Consensus proposal for Rx tolerance tests changes in clauses 110 and 111

Background

Main goals

Proposed updated figures

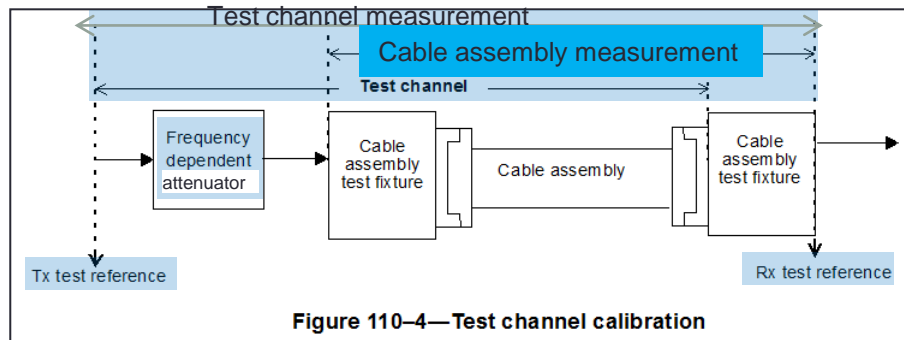
Test setup, reference points

- Test channel construction is per Figure 110–3
 - Cable assembly: specify [range of CA fitted IL @12.8906 GHz](#) in each table 
 - Test 1: no less than minimum (from Table 110A–1), and within 2 dB of that minimum

- Test 2: no more than maximum per CA type (from Table 110A–1), and within 2 dB of that maximum
 - “Additive host board loss”
 - Rename to “[Frequency-dependent attenuator](#)”.

- Add NOTE: “[The frequency-dependent attenuator represents the host channel and may be implemented with PCB traces and test cables](#)”.
- The term “PGC” should be changed to “[Tx test reference](#)”

- Noise is added before and measured at the Tx test reference
 - Noise combiner effects, such as flat loss or reflections, are part of the test transmitter.

- Rx test reference is after a CA test fixture.
- In 110.8.4.2.2 (test channel), set first sentence to
The test channel ([depicted in Figure 110-3](#)) consists of the following:

- (See [later slide](#) for proposed updated figures)
